Franklin Municipal Planning Commission

Thursday, April 26, 2018 | **7:00 PM** | **Board Room**

1st and Main, site plan (Mixed Use) - submittal 004

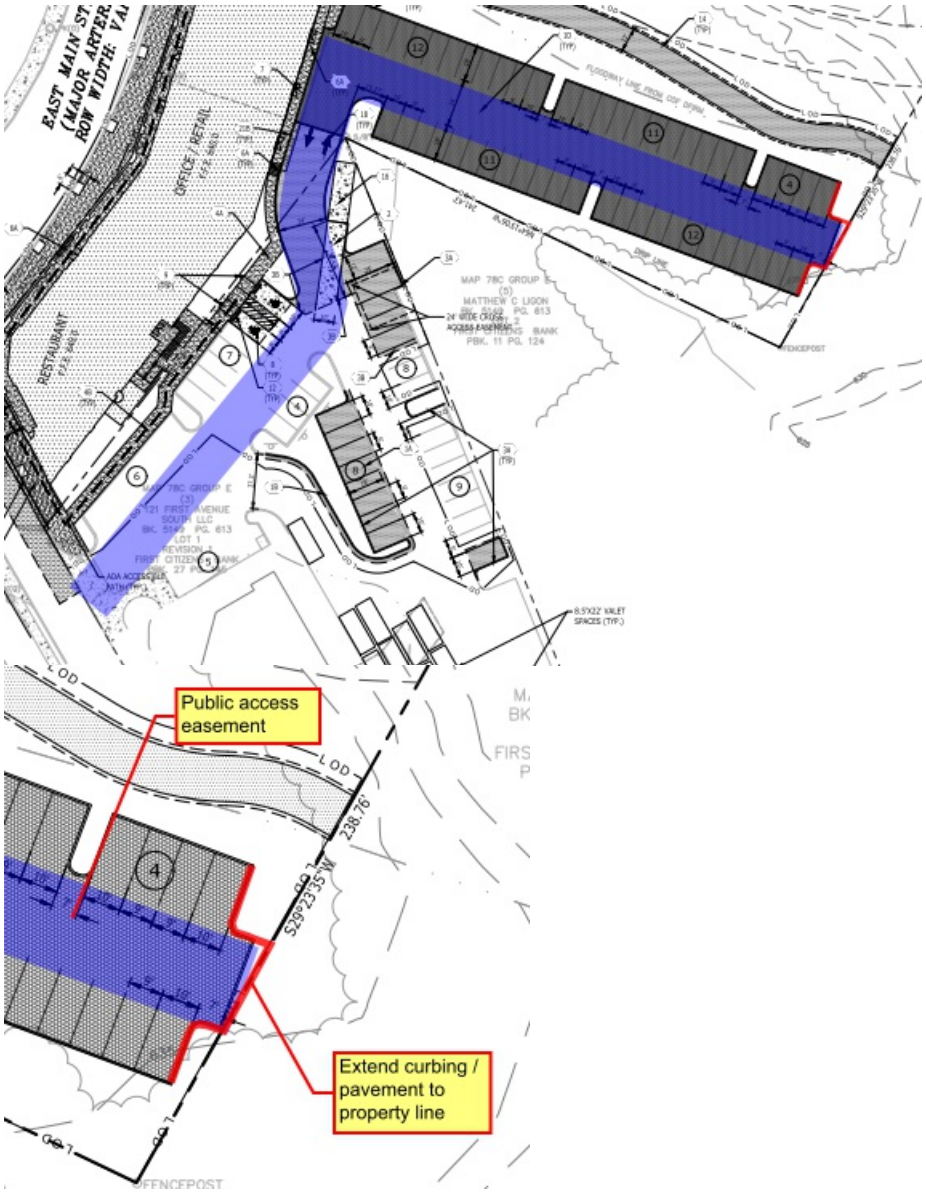
joe.marlo@franklintn.gov *Comment not adequately addressed. Applicant to provide stub connection(s) to the property line and showassociated public access easements for cross access connections on the Site Plan. Cross access is to be from the project development (1st and Main Development), not the neighboring site.*

Applicant to provide the cross access shown below.
